BRATTLEBORO BHF 2000 (17)
US 5 (T.H.1); BRIDGE 7

PROPOSED IMPROVEMENT
BRIDGE PROJECT
TOWN OF BRATTLEBORO
COUNTY OF WINDHAM

PROJECT DESCRIPTION : THE PROJECT SHALL CONSIST OF THE REHABILITATION OF BRIDGE NO.7 ALONG WITH RELATED ROADWAY APPROACH WORK.

RECORD PLANS

CONSTRUCTION SIGN DETAIL (4)

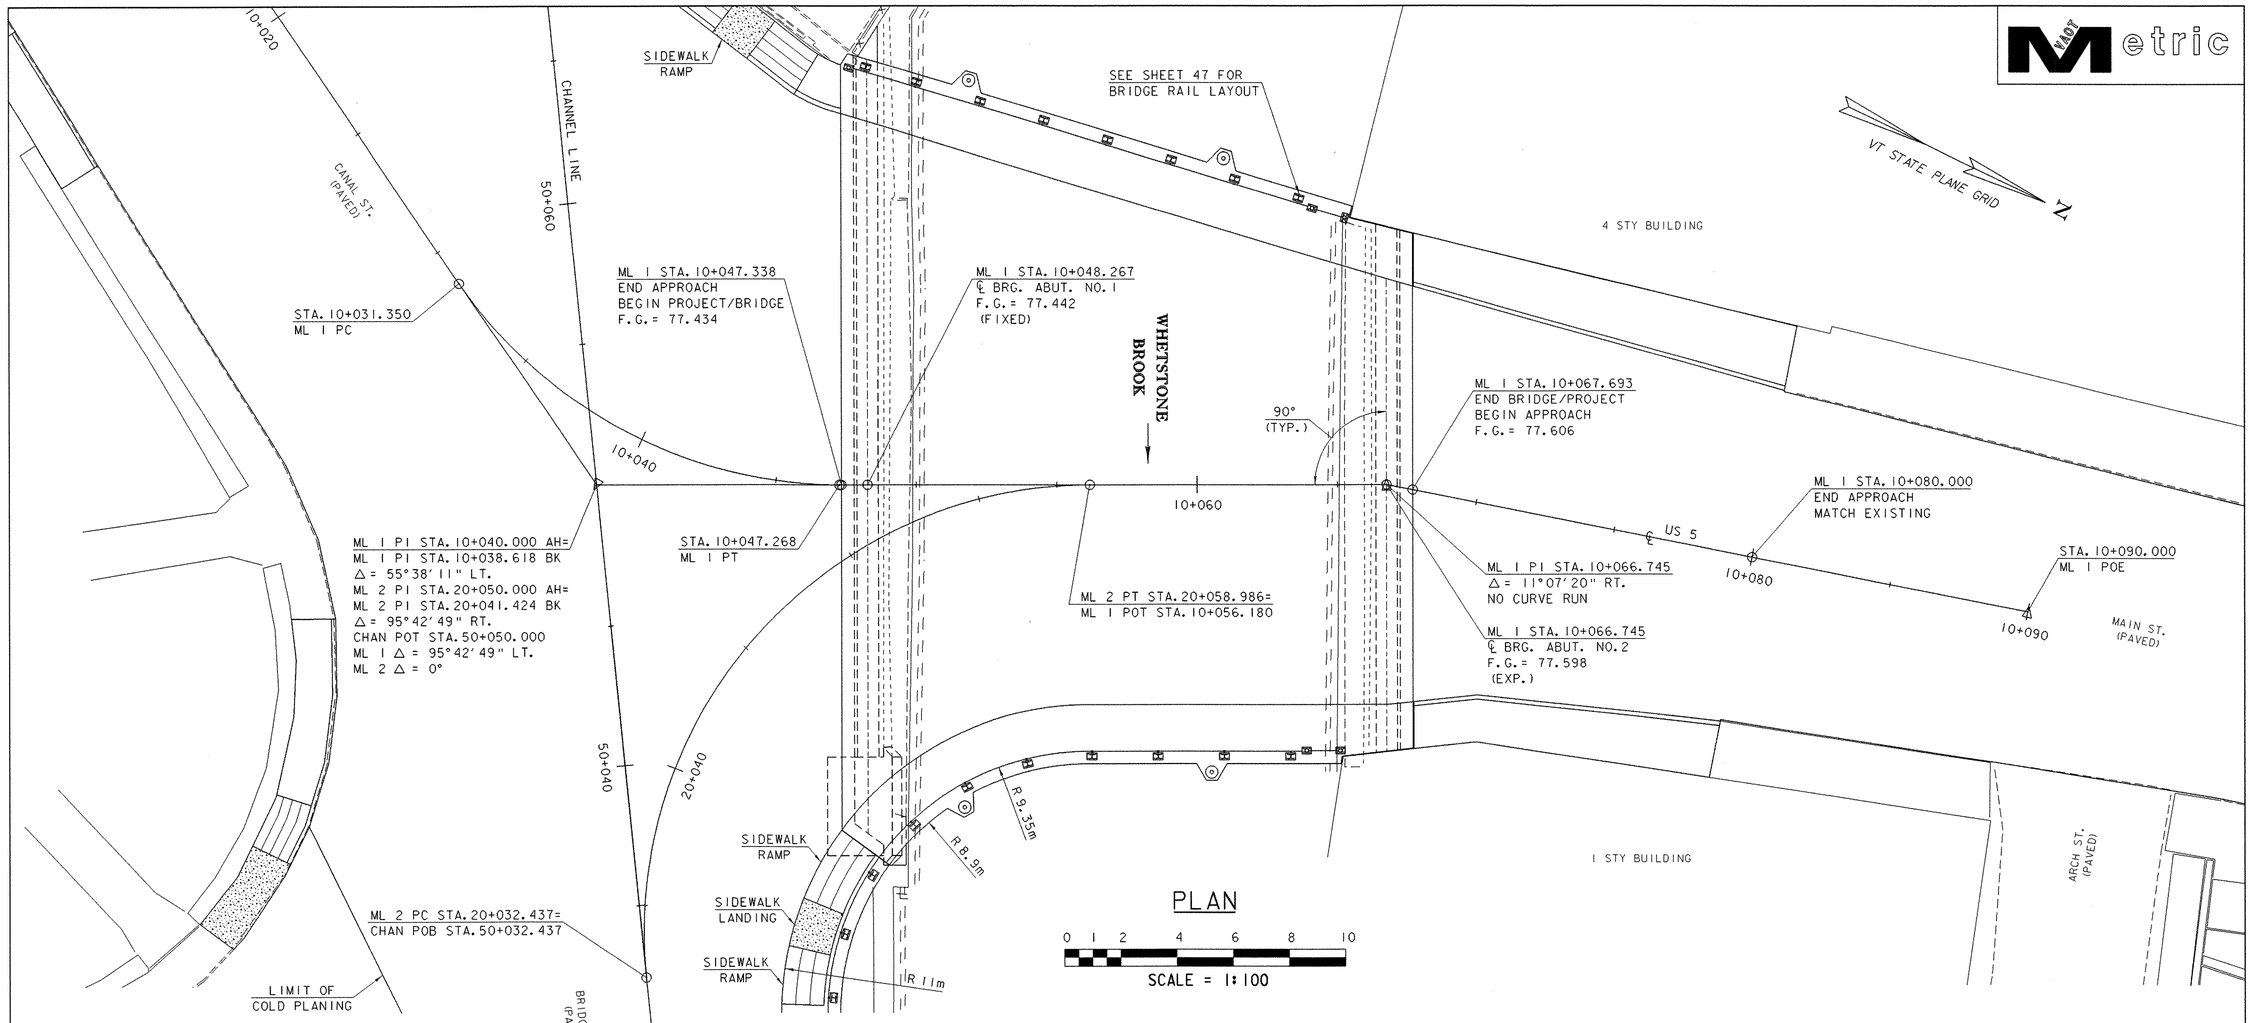
△ Revised by VAOT 3/10/03
Size of Sign Changed

PLAN VIEW
1" = 40'

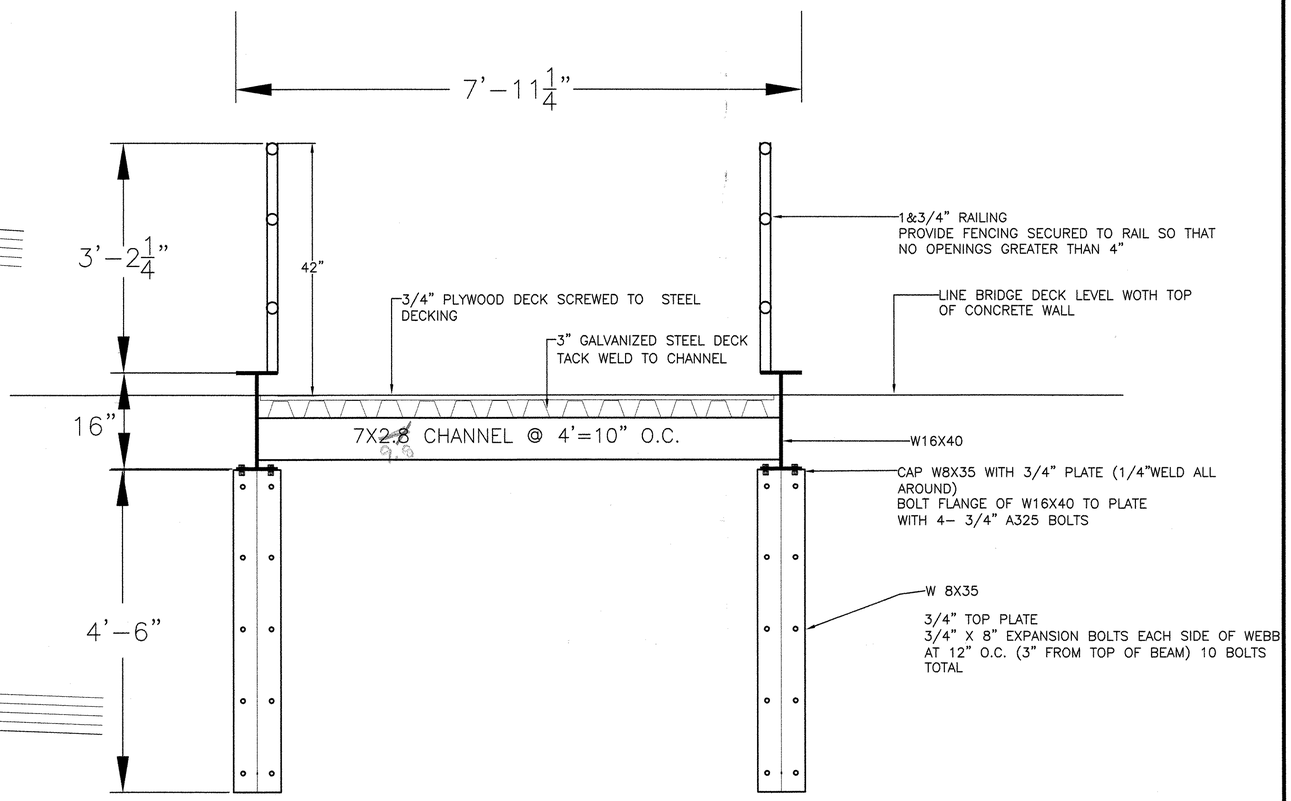
NOTE: THE BRIDGE IS PERPENDICULAR TO THE CONCRETE WALL ON THE NORTH SIDE. THEREFORE SHORTEN THE SOUTH WEST BEAM.

EXPANSION BEARING DETAIL- ABUTMENT NO. 2

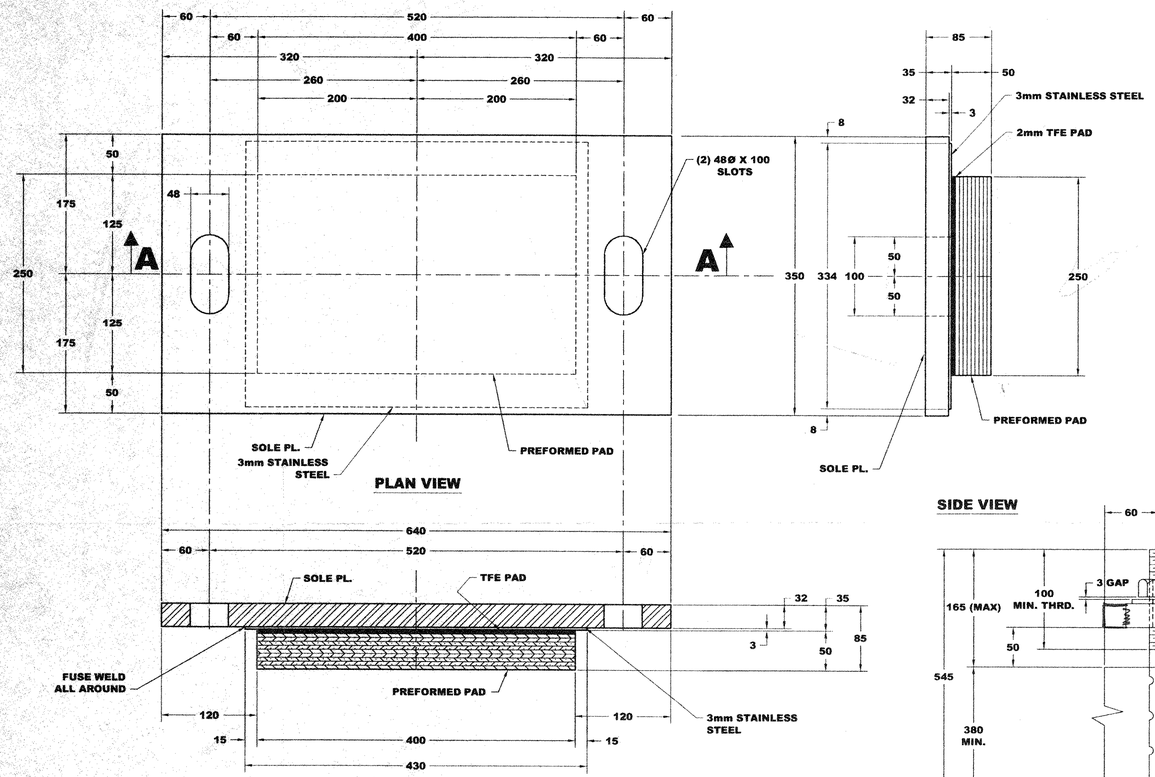
Add same notes as sheet 1 plus: "The surface finish of the contact (sliding) face shall have a mirror finish as per spec. 731.05."

FRAMING PLAN

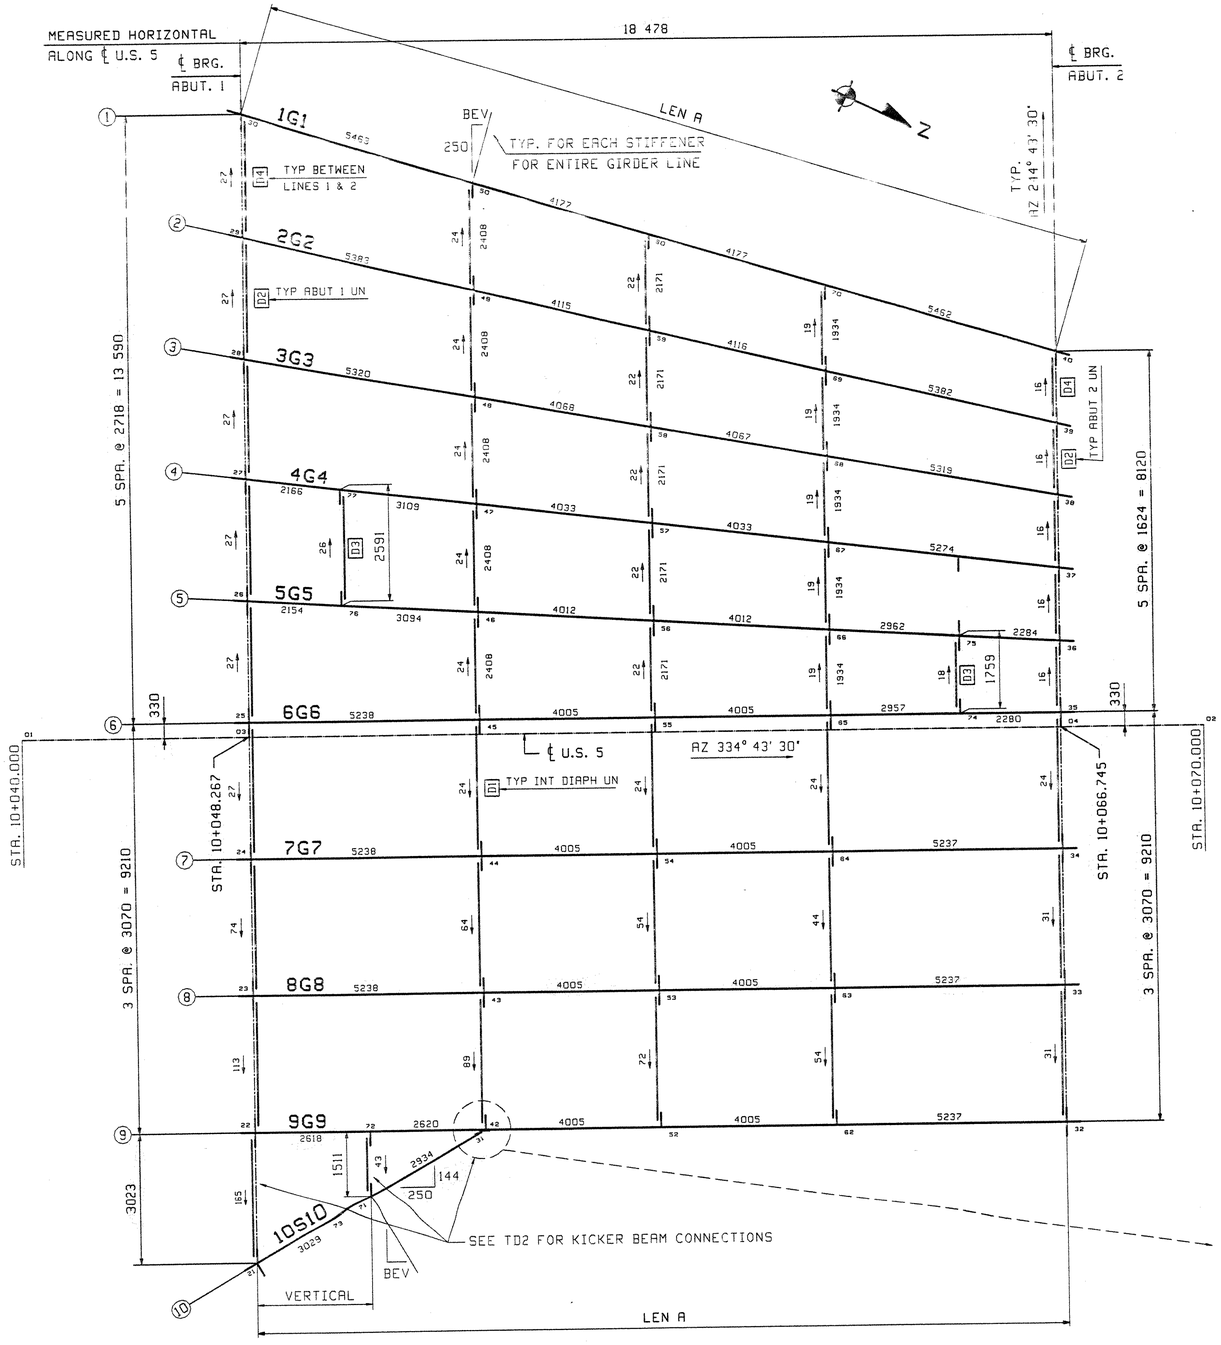
V.A.O.T.
RECEIVED
CK'D BY J.S.S. 4/16/03 OK'D BY JMP 4/15/03
APR 15 2003
RESUBMIT ____ APPROVED X
BY DATE

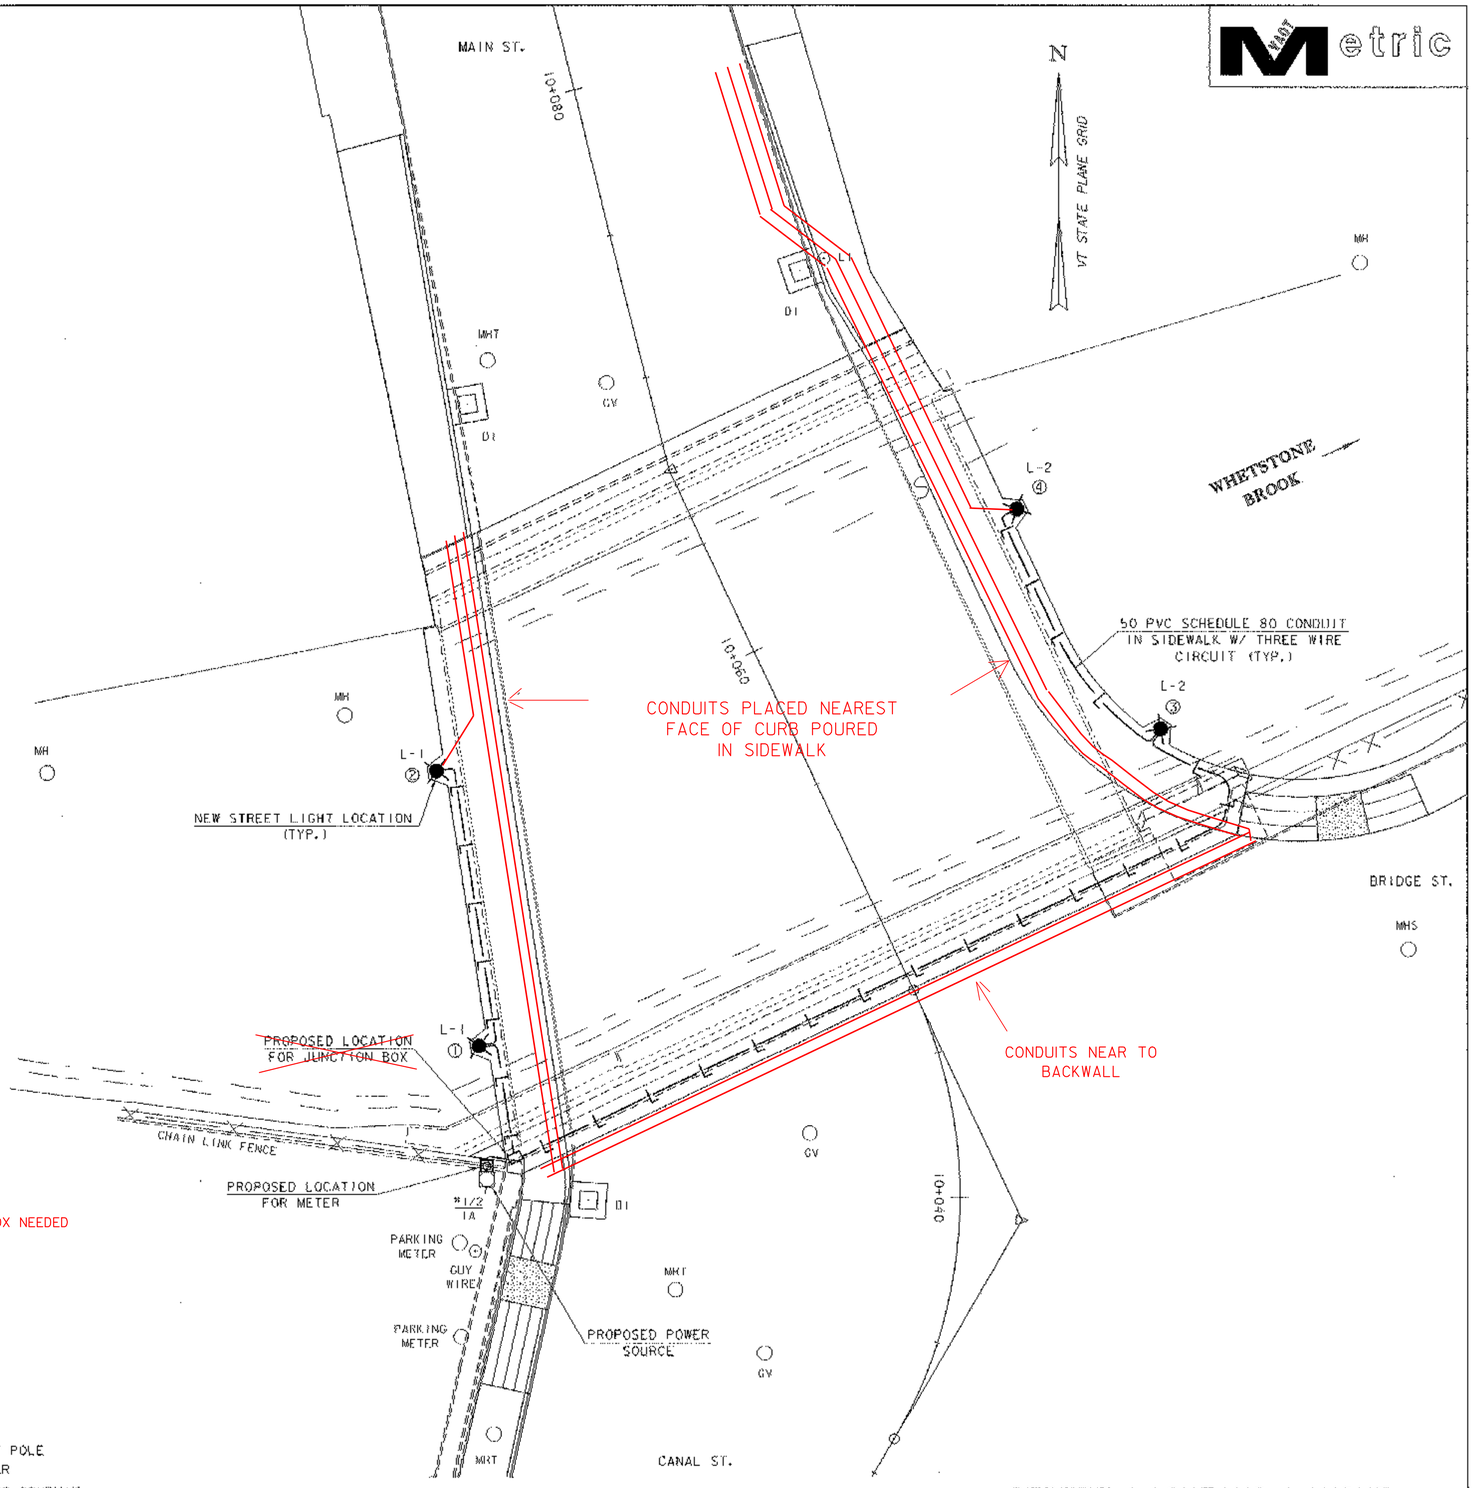
3. INSTALL ALL ~~JUNCTION BOXES,~~ THE CONDUIT, PHOTOCELL AND WIRING AS DETAILED ON PLAN DRAWINGS. NO JUNCTION BOX NEEDED

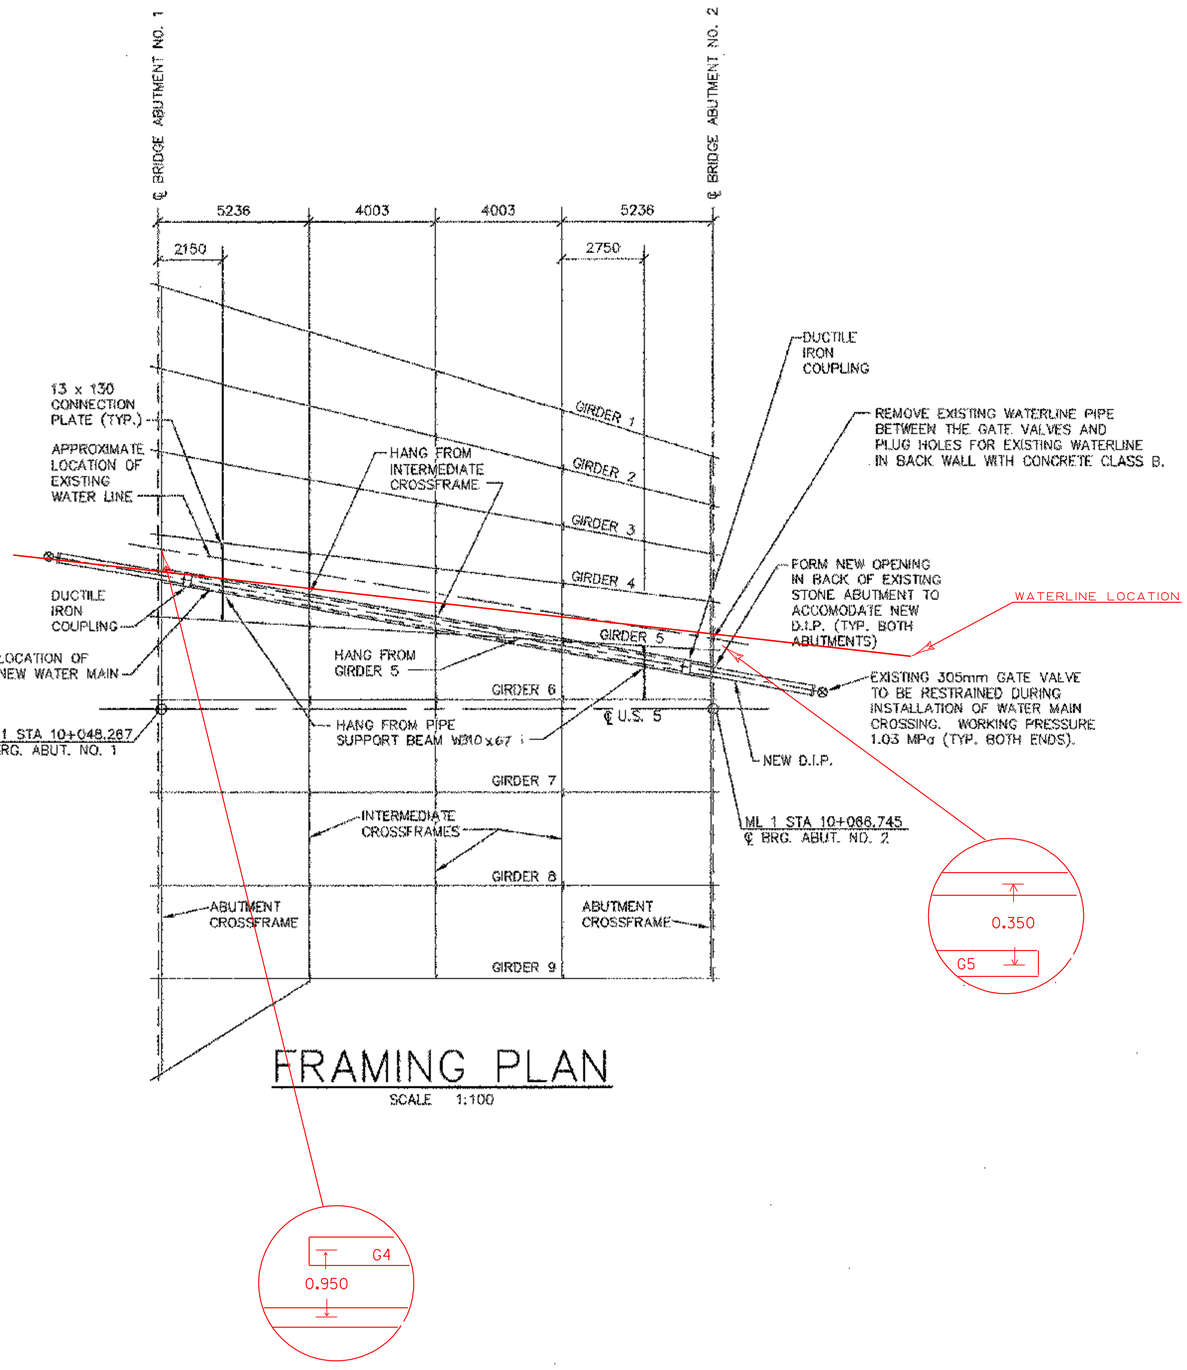
* SEE DAILY REPORT #46, DATED 6/18/03
UNABLE TO CONNECT THIS CONDUIT -
WOULD HAVE HAD TO CUT BEARING PLATE
OK'D BY NEIL SNYDER OF VERIZON

ORNAMENTAL RAIL DETAILS (1)

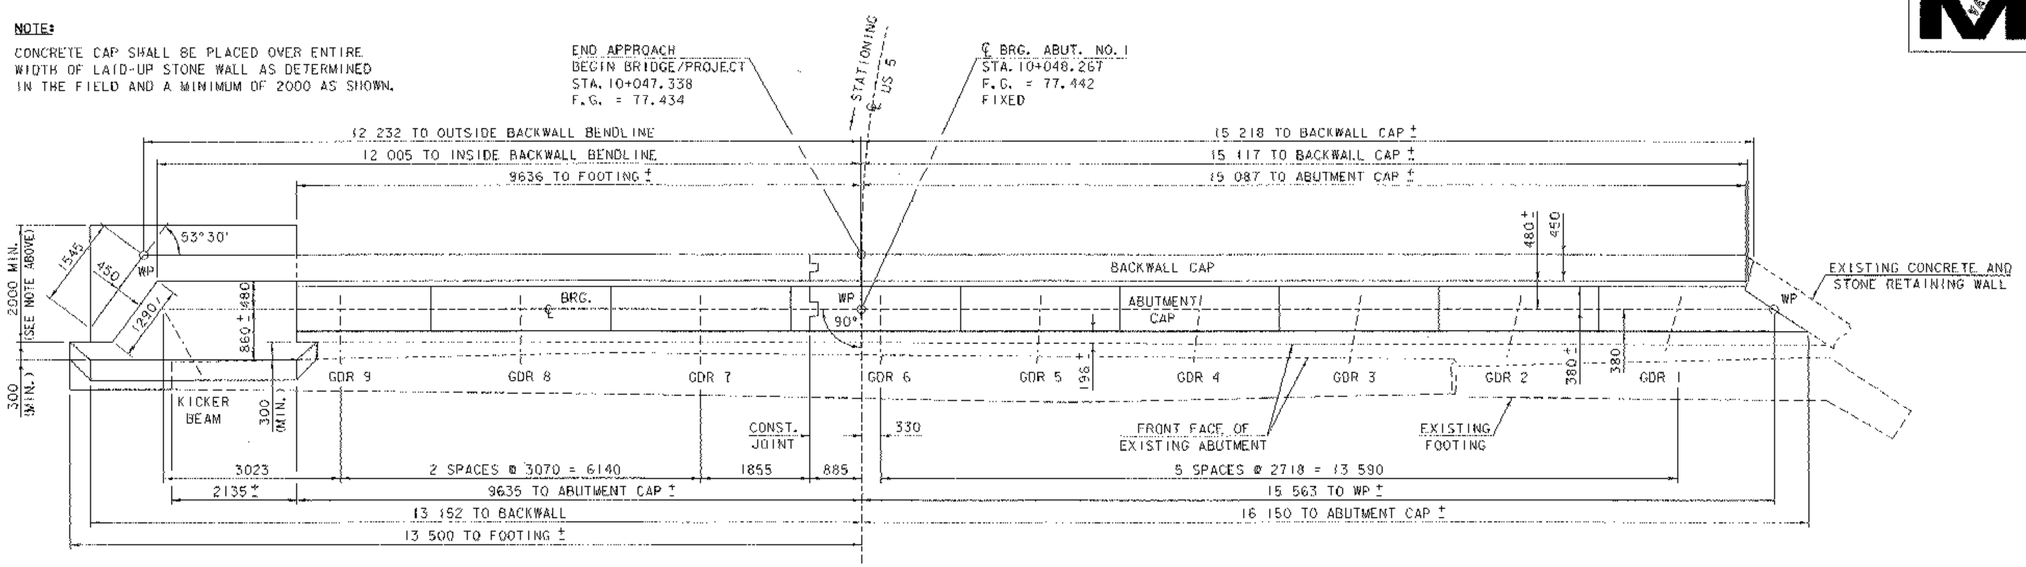
CAST BOLTS HAD DIFFERENT BOLT PATTERN
HAD TO CUT BOLTS POURED IN PLACE, DRILL
& EPOXY NEW ONES IN PLACE
